Memorandum to the City of Markham Committee of Adjustment

February 09, 2018

File: A/171/17
Address: 11 Fredericton Road, Markham
Applicant: Anna Maria Sgouros & Nichoals Steve Kalantzis
Agent: SDG Design (Stefano Di Giulio)
Hearing Date: Wednesday February 21, 2018

Re: Variance Application - A/171/17
11 Fredericton Road, Markham, ON
Anna Maria Sgouros & Nicholas Steve Kalantzis (Owner)
Stefano Di Guilio (Agent)

DWG. No. ASK-2

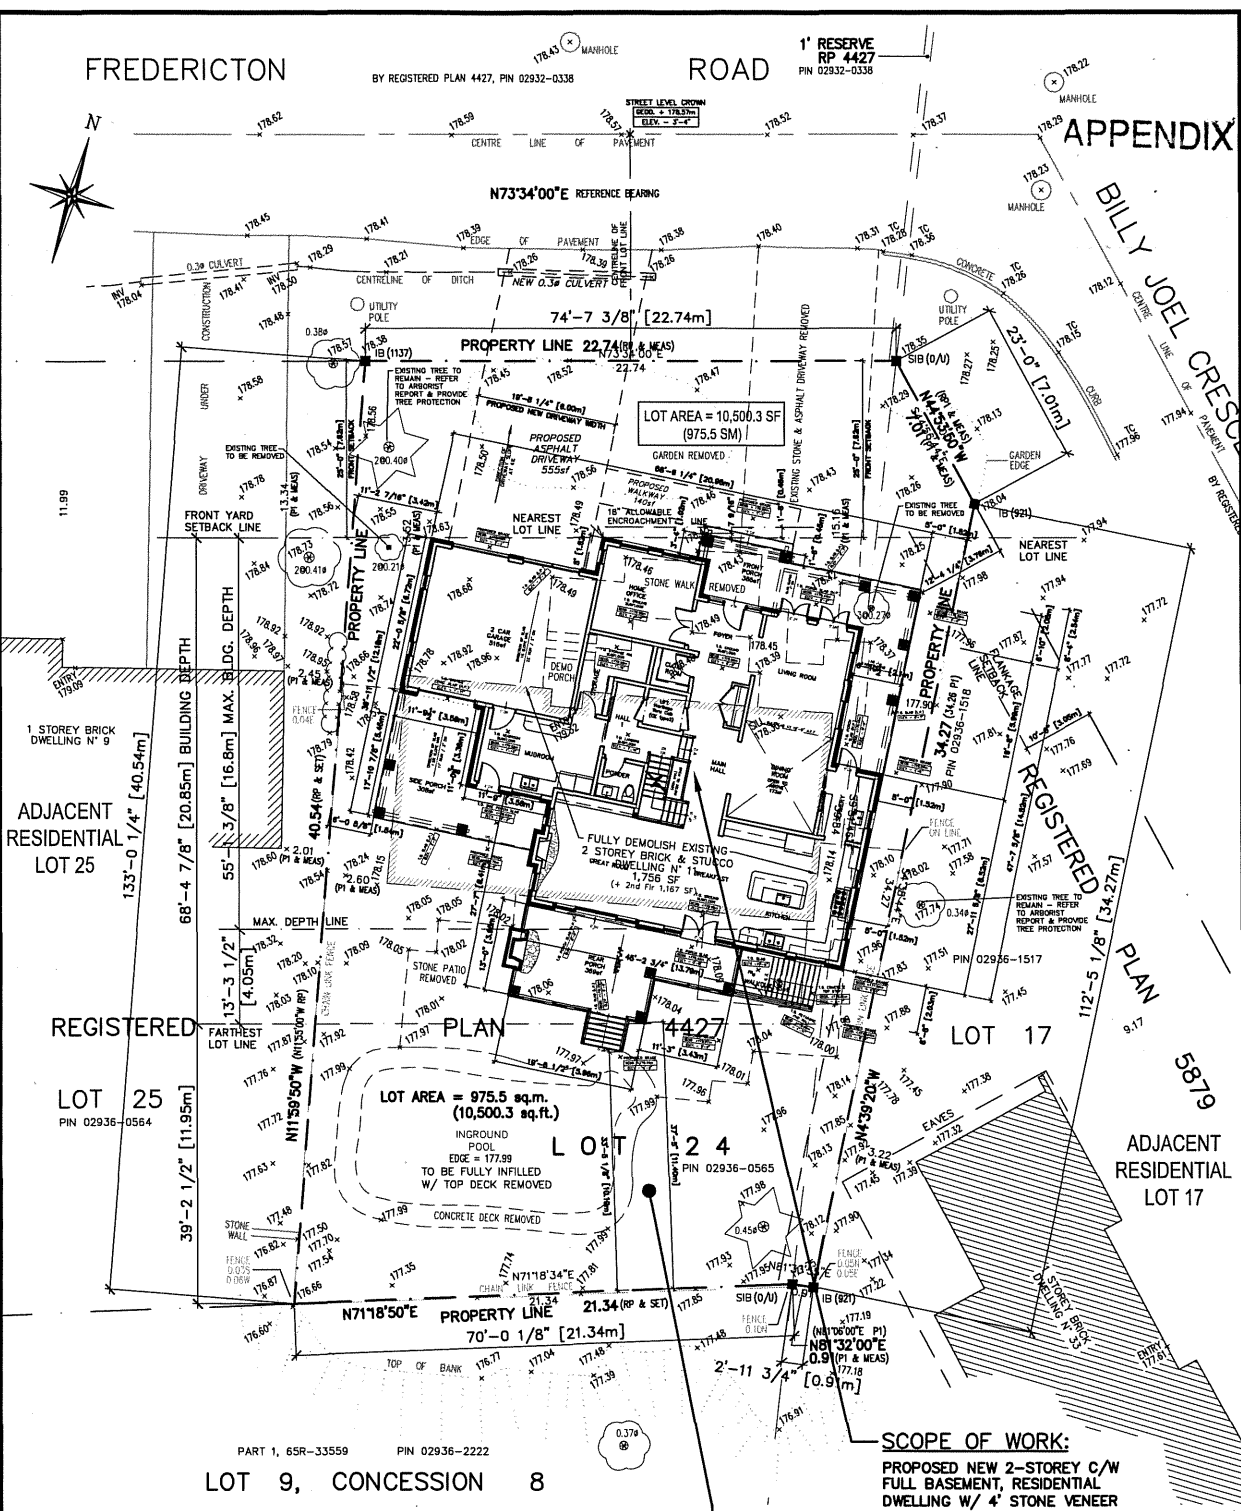
The applicant is requesting relief to permit a maximum lot coverage of 35.46 percent, whereas the By-law permits a maximum lot coverage of 35 percent. Staff are of the opinion that the proposed lot coverage represents a modest increase from the by-law.

The applicant is requesting relief from the by-law to permit a maximum building depth of 20.85 m (68.4 ft), whereas the by-law permits a maximum building depth of 16.8 m (55.11 ft). This represents an increase of 4.05 m (13.28 ft). Building depth is measured based on the shortest distance between two lines, both parallel to the front lot line, one passing through the point on the dwelling which is the nearest and the other through the point on the dwelling which is the farthest from the front lot line. Given the configuration of the lot, building depth is measured on an angle through the proposed building.

The proposed building depth includes the front and rear covered porches, which combined add approximately 4.98 m (16.33 ft) to the overall depth of the building. The actual length measured between the front and rear main wall, excluding the front and rear covered porch, is 16.11 m (52.85 ft), which complies with the by-law requirement. Notwithstanding the increase in depth, the dwelling will provide a rear yard setback of 11.4 m (37 ft), which is approximately more 3.78 m (12.4 ft) more than what the by-law requires.

As noted above, the subject property is within a TRCA Regulated Area of the Rouge River Watershed. Based on our review, TRCA staff have concerns with respect to the requested variances as they relate to the location of the proposed works identified on the plans submitted with the subject application.

Based on the results of our site visit on December 7, 2017, the footprint of the proposed replacement dwelling is situated approximately 5m closer towards the TOB than the existing dwelling. Additionally, it is our understanding that the existing in-ground pool and concrete top decking will be infilled/removed. These structures/landscaping were observed to be approximately setback 5-6 metres from the TOB.

Please be advised, where existing development is outside the 10m environmental buffer from natural features and their associated hazards, TRCA does not typically support further encroachment and will not permit development within the erosion hazard limit.

1. Given the proposed works proximity towards the steep valley wall, we are concerned that it may be encroaching within the Erosion Hazard Limit of the LTSTOB, representing an increase in risk to life and property which TRCA cannot support. Therefore, in accordance with TRCA policy, to assess slope stability and erosion risk on site, a geotechnical investigation is required to delineate LTSTOB and determine an appropriate setback.

To prevent sediment from potentially leaving the subject site and from entering into the valley corridor, ESCs (i.e. silt fencing) are required. Should you wish to adhere to the above noted comments and proceed with the proposed works, please ensure that all relevant plans/drawings are revised to demonstrate that ESCs in accordance with TRCA's *Erosion and Sediment Control Guideline for Urban Construction, December 2006*. The ESCs should cover the full extent of the construction area associated with the proposed works throughout all phases of construction until the completion of the project. Please note, typical silt fencing details (OPSD 219.130) should be included on all relevant plans/drawings (see: Appendix C [C-26] of TRCA's Erosion and Sediment Control guidelines for Urban Construction, 2006 – <http://trca.on.ca/dotAsset/40035.pdf>).

Based on the discussion above, Staff recommend this application be deferred to provide the applicant an opportunity to work with TRCA to address the comments identified in the TRCA letter dated January 9th, 2018 (Appendix C) and to determine how the proposed dwelling and variances are impacted.

Based on the above, TRCA staff cannot support the above noted application and request that it be **deferred** until such a time that the applicant addresses the geotechnical issue outlined in this letter. Please note, based on our review of your revised submission, additional comments may arise.

DWG. No. **ASK-8**

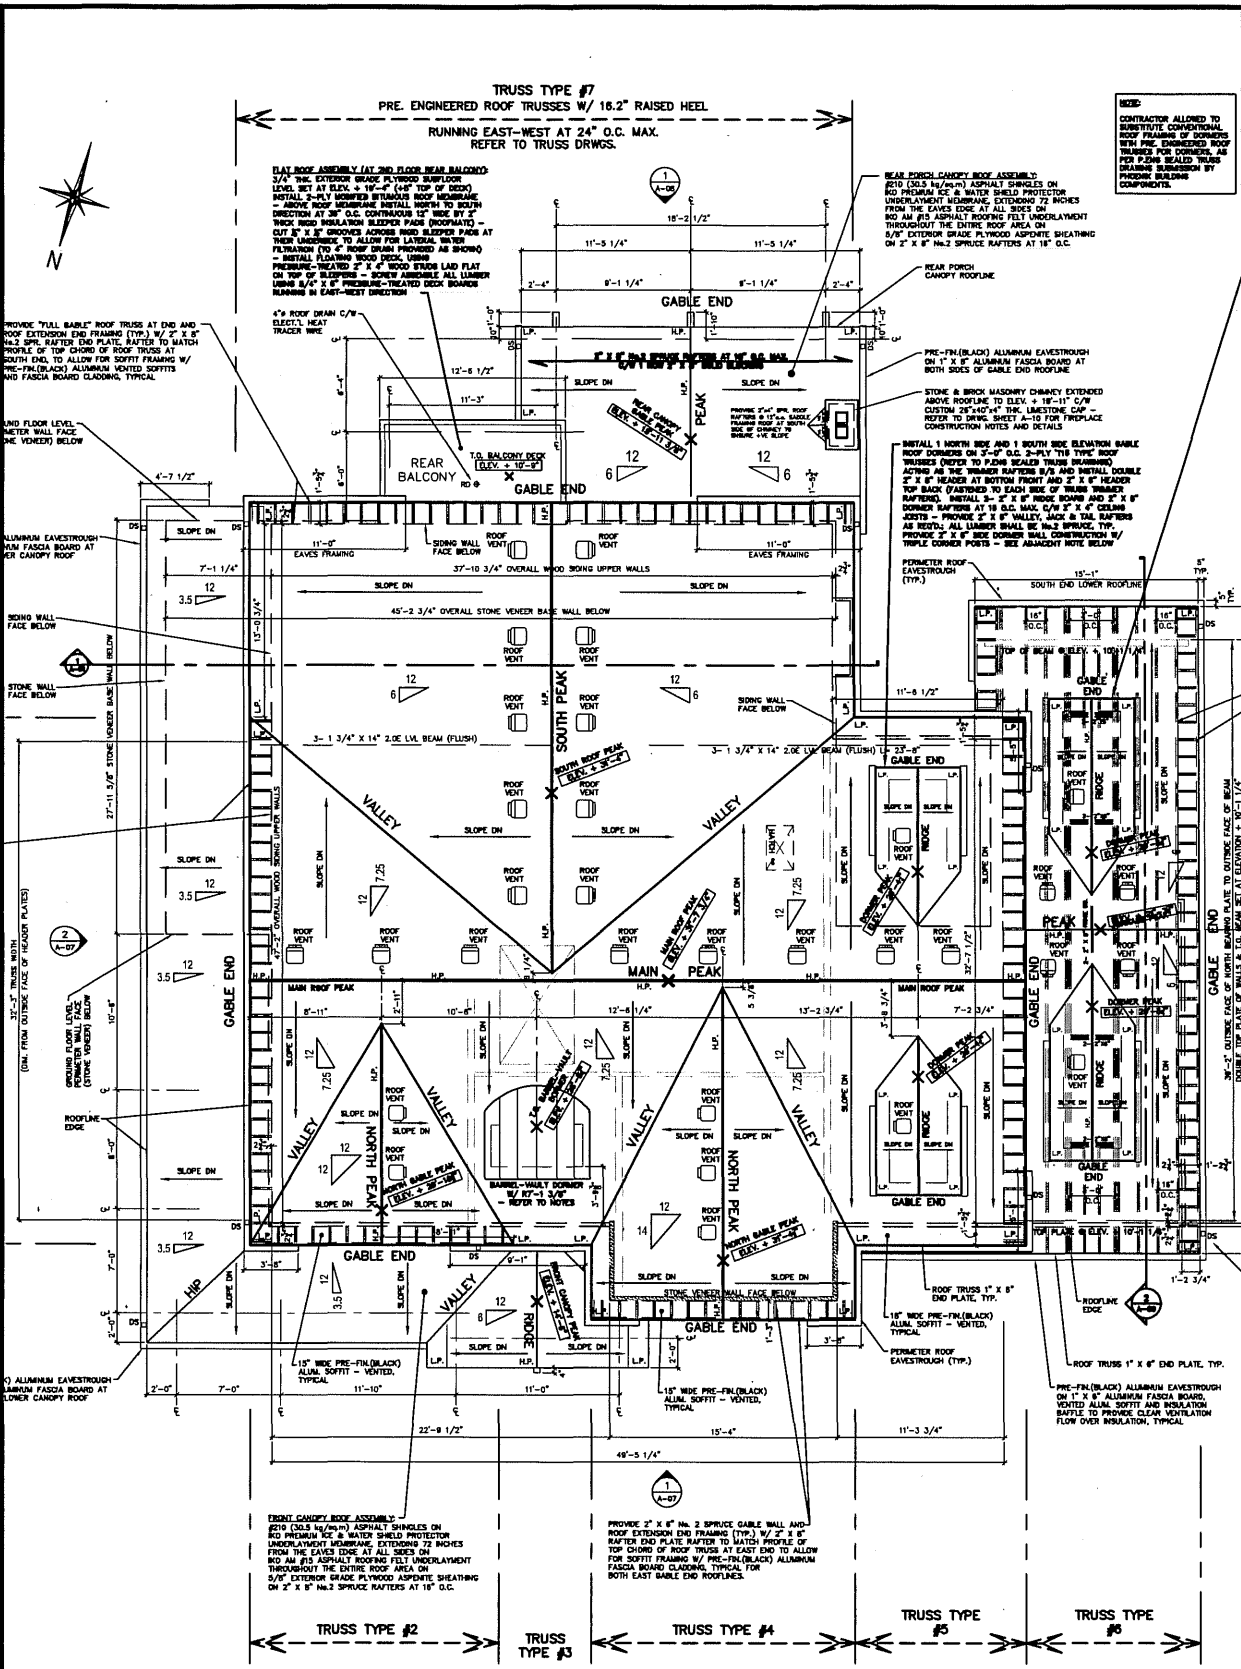
The applicant is requesting relief to permit a maximum building height of 10.66 m (34.97 ft), whereas the By-law permits a maximum building height of 9.8 m (32.15 ft). This represents an increase of 0.86 m (2.82 ft). The By-law calculates building height using the vertical distance of building or structure measured between the level of the crown of the street and highest point of the roof surface. It should be noted that the proposed grade of the front of the house is approximately 0.33 m (1.08 ft) above the crown of road.

Many parts of the second storey is setback from the main floor to help break down the vertical massing of the proposed dwelling. This also allows the second floor to provide more separation from adjacent homes to alleviate shadowing impact. The peak of the building will be approximately 7.74 m (24.4 ft) away from the adjacent home to the east, and 8.84 m (29 ft) from the home to the west.
